Access Compliance Report

Public Rights-of-Way

(Curb Ramps)

Intersection ID: 12519	Main Street: E_6TH_ST	Cross Street: N_CALDWELL_ST	Location: N
ADA ID: EF55EE141442	Ramp Type: PerpDiag	Initial Pass/Fail: Fail	Overall Compliance: No
			Severity Score: 58.75

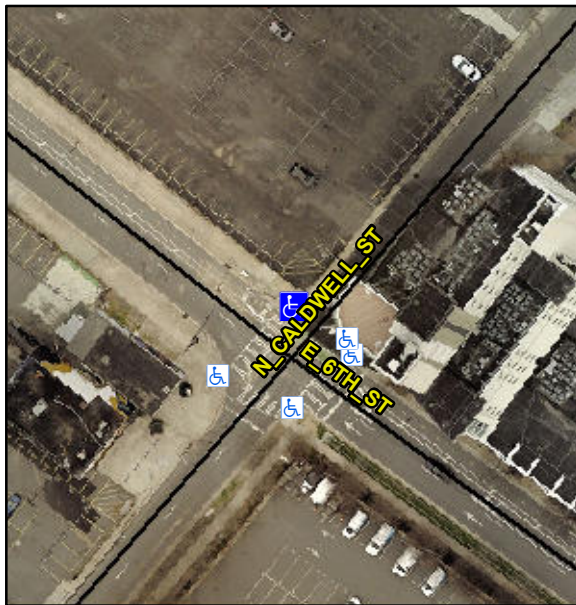
Not Found, R304.5.1, R304.2.2, R304.5.3

Compliance	Description	Data	Compliance	Description	Data
N/A	Ramp Length (in)	58.0	No	Ramp Slope (%)	14.1
No	Ramp Width (in)	41.0	No	Ramp XSlope (%)	9.5
N/A	Flare Type LT	N/A	N/A	Flare Type RT	N/A
N/A	Flare Slope LT (%)	N/A	N/A	Flare Slope RT (%)	N/A
N/A	Flare Traversable LT?	N/A	N/A	Flare Traversable RT?	N/A
N/A	Landing Length (in)	N/A	N/A	DWS Provided?	N/A
N/A	Landing Width (in)	N/A	N/A	DWS Contrast?	N/A
N/A	Landing Slope (%)	N/A	N/A	DWS Length (in)	N/A
N/A	Landing X Slope (%)	N/A	N/A	DWS Full Width?	N/A
N/A	Landing Curb? (Y/N)	N/A	N/A	DWS Offset (in)	N/A
N/A	Shared Landing?	N/A			
N/A	Gutter Ponding?	N/A	N/A	Gutter Slope (%)	N/A
N/A	Gutter Lip Ht (in)	0.5	N/A	Gutter X Slope (%)	N/A
N/A	Painted X Walk1?	Yes	N/A	Painted X Walk2?	Yes
	X Walk 1 Direction	To SW		X Walk 2 Direction	To SE
N/A	X Walk 1 Width (in)	110.0	N/A	X Walk 2 Width (in)	109.0
	X Walk 1 Slope (%)	2.9		X Walk 2 Slope (%)	2.6
	X Walk 1 X Slope (%)	3.0		X Walk 2 X Slope (%)	5.2

Remove & Replace Curb Ramp With Two New Directional Ramps or Equivalent.
